REF.: H-P-ASP-MN-4307	
				SPIRE Progress & Interface	
				DATE: 10/02/04	PAGE: 1/14
COMpte Rendu de Reunion / MINUTES OF MEETING				LIEU / PLACE: RAL Chilton	
OBJET / PURPOSE:				CLASSIFICATION:	
SPIRE Progress & Interface Meeting					
PARTICIPANTS ATTENDEES	SOCIETE FIRM	SIGNATURE SIGNATURE	PARTICIPANTS ATTENDEES	SOCIETE FIRM	SIGNATURE SIGNATURE
Guy Doubrovik	ASP		John Delderfield	RAL	
Bernard Collaudin	ASP		Eric Sawyer	RAL	
Carsten Scharmberg	ESA		Doug Griffin	RAL	
Horst Faas	ASED				
Marco Cesa	ALS		Chris Bockley-Blatt	MSSL	
Jan Rautakoski	ESA		John Coker	MSSL	
REDACTEUR / WRITTEN BY:					
Bernard Collaudin					
CONCLUSION:					
DISTRIBUTION: PARTICIPANTS / ATTENDEES	POUR ACTION: FOR FURTHER ACTION				
	POUR INFORMATION: FOR INFORMATION				
APPROUVE PAR / APPROVED BY					
NOM / NAME					
SIGNATURE / SIGNATURE

IID-B issue 3.11 status

Annex 2: SPIRE Hoisting device drawing.

SPIRE SIH Double-Over-Shield and Cable-Shield
Interconnection Design
between Warm and Cold-Units

DEPARTMENT OF SPACE AND CLIMATE PHYSICS UNIVERSITY COLLEGE LONDON MULLARD SPACE SCIENCE LABORATORY, HOLMBURY ST. MARY, DORKING, SURREY.		DRAWING No	
TITLE SPIRE LIFTING FOR INSTALLATION		A1	5264 404 SHT 6 OF 7

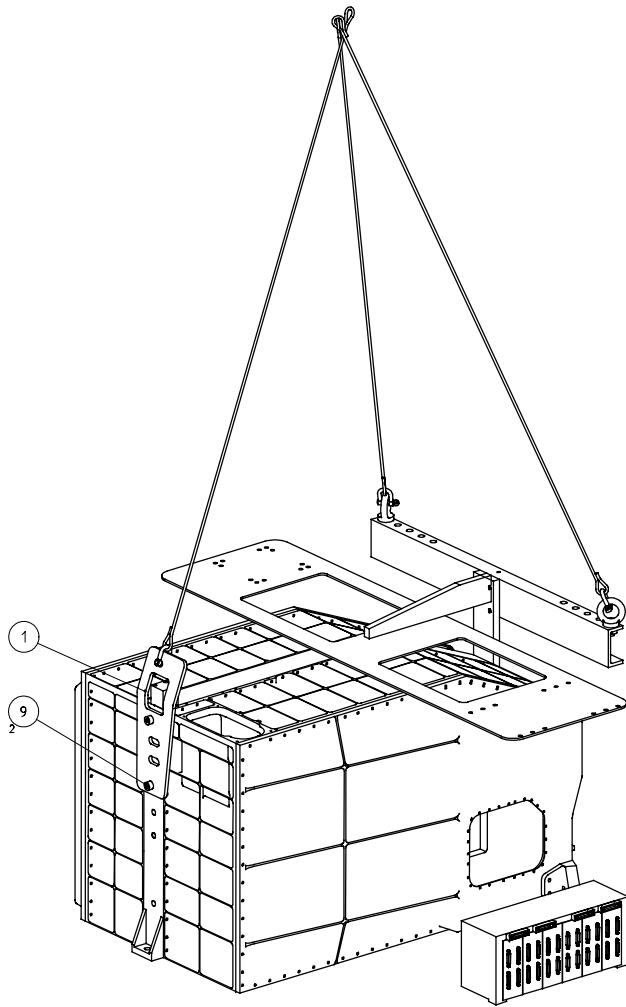
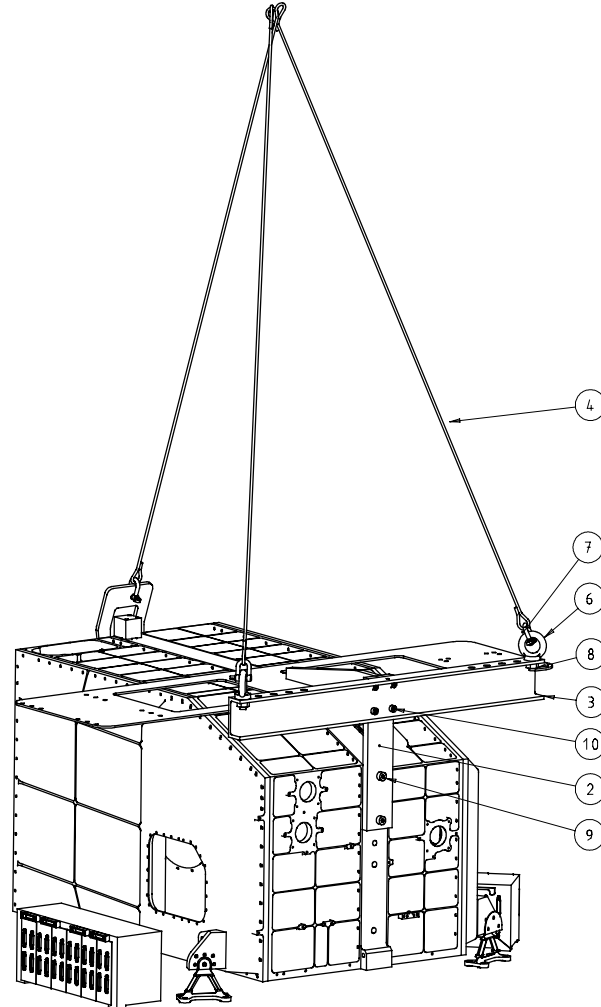
Shall be in agreement with the integration procedure. (comments from ASED). New arrangement with FPU and JFET that shall be now be integrated connected together is critical for integration in the FPU. Hoisting device supports both FPU + JFET. (ASED base line was independent integration of FPU then JFET)

This information is urgently needed (for HPLM CDR)

A sketch of the MGSE is handed out during this meeting (hoisting device)

Drawing MSSL A1 5264 404 (2/2/04) sheet 6/7 **see annex 2**

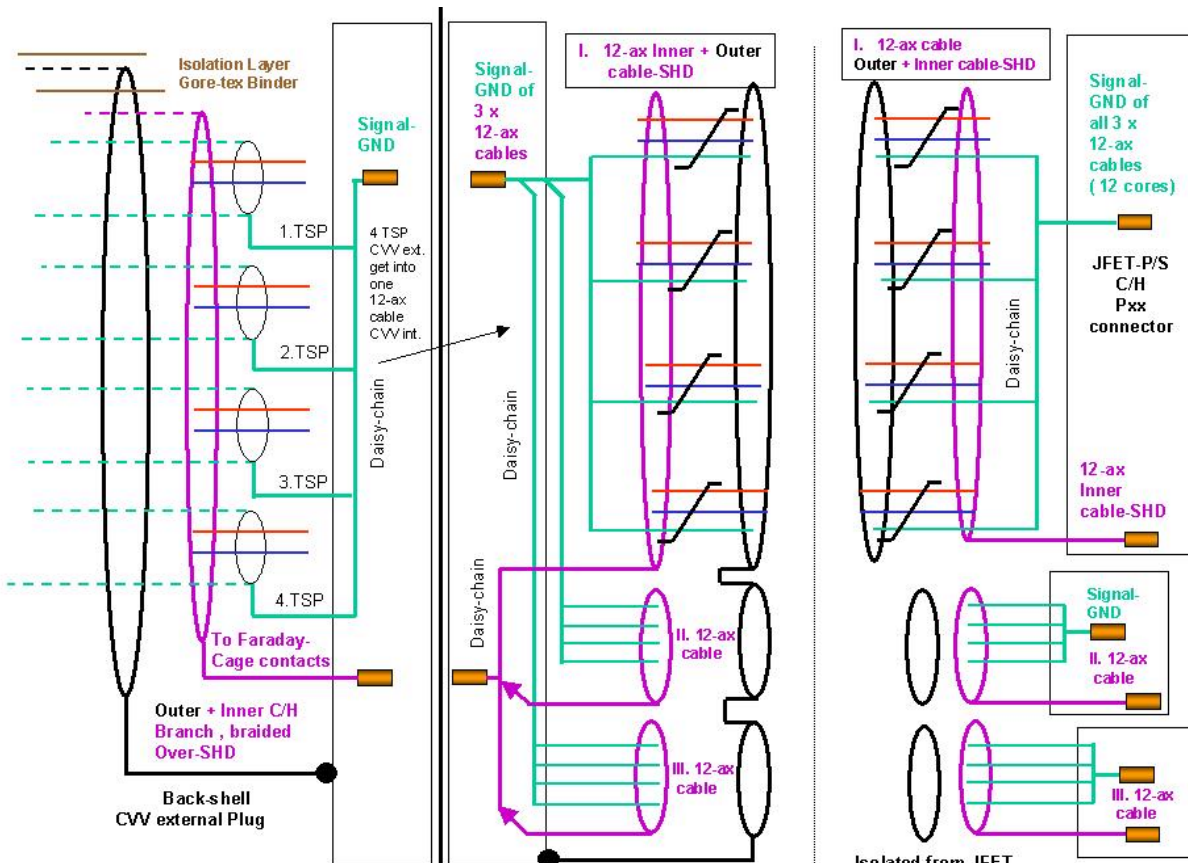
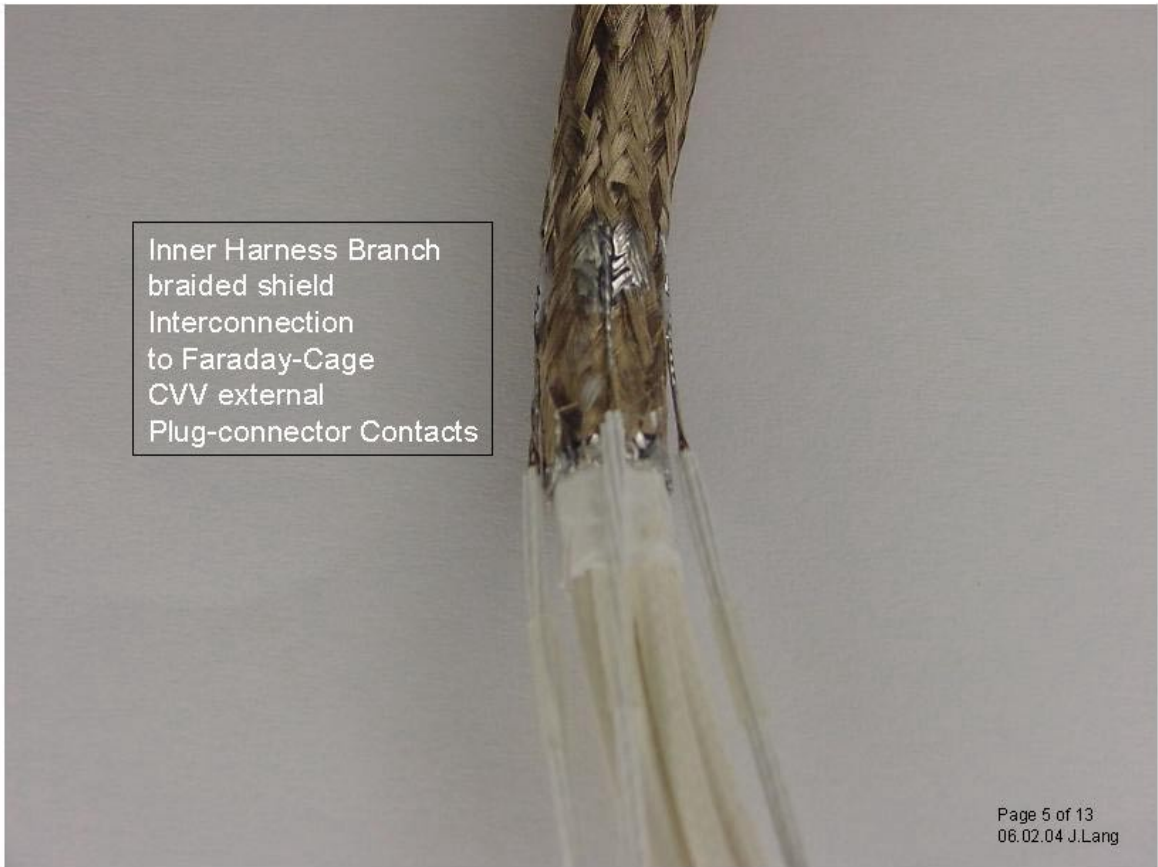
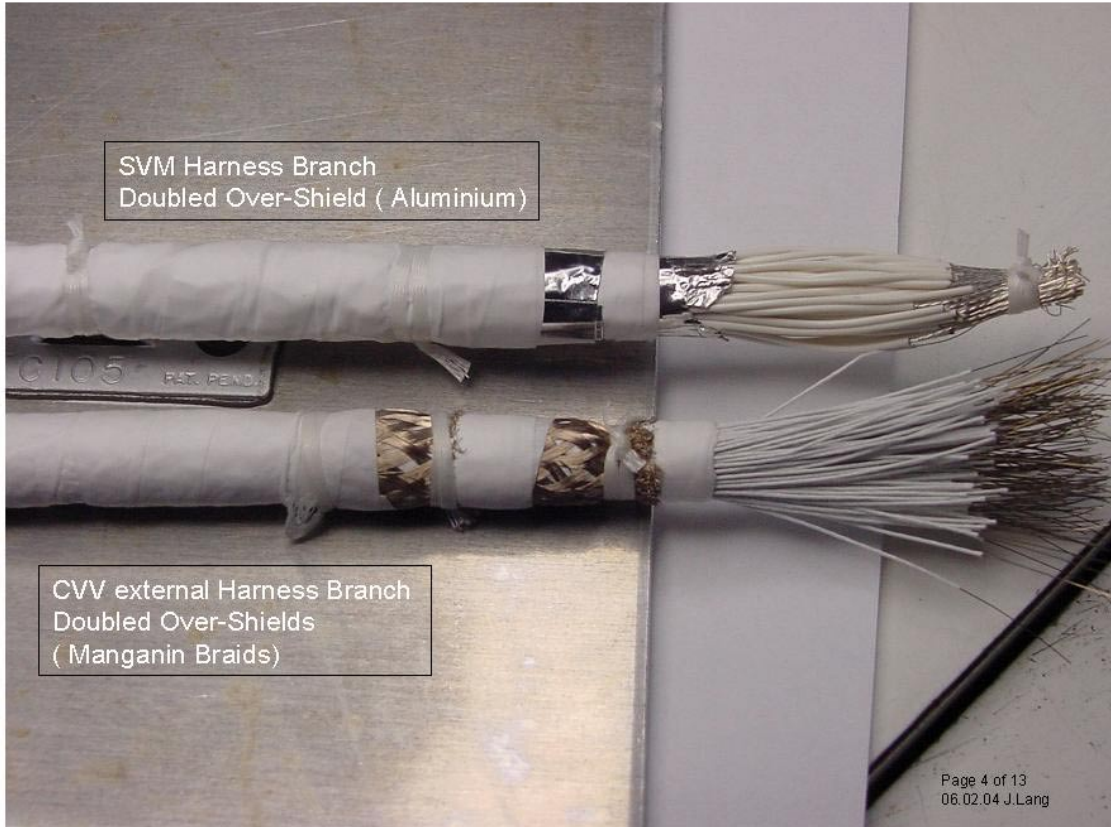
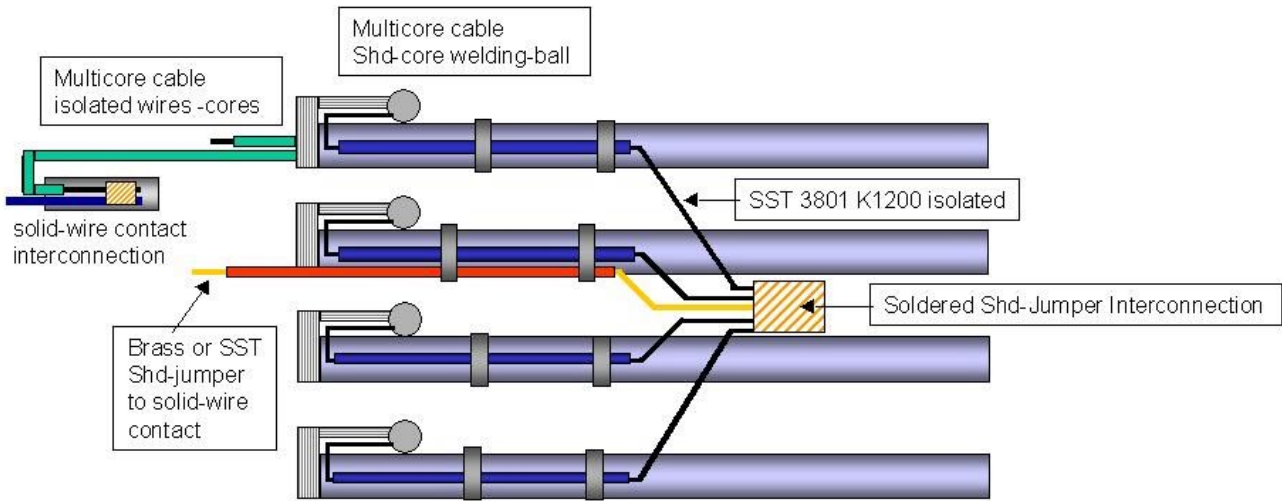
P1/13 of attachment– SPIRE double shielded branch design on the SVM: Faraday shield shall be connected to the backshell by removable cable lugs, and not connected to pins

P2/13: Gore-tex binder isolation (outside of the overshield) is acceptable by SPIRE. Astrium will raise an RFD against GDIR as this definition violates the GDIR (conductive coating

- Signal ground wire of individual 12-ax cable form a single ground plane. All ground wires are commoned in the 128 ways connectors.. The exception is the C2 branch where SSW & PTC ground planes are kept separate.
- for internal cryoharness, outer shield shall be the faraday cage, and internal shield shall be the signal ground. There is a misinterpretation of this point in the p3 of the annexe 4 document, which shall be corrected. (connect green (ground wires) to magenta (12-axe inner shields)).
- See corrected p 3 in annex 4

ASED to update the harness shield definition according to this clarification.
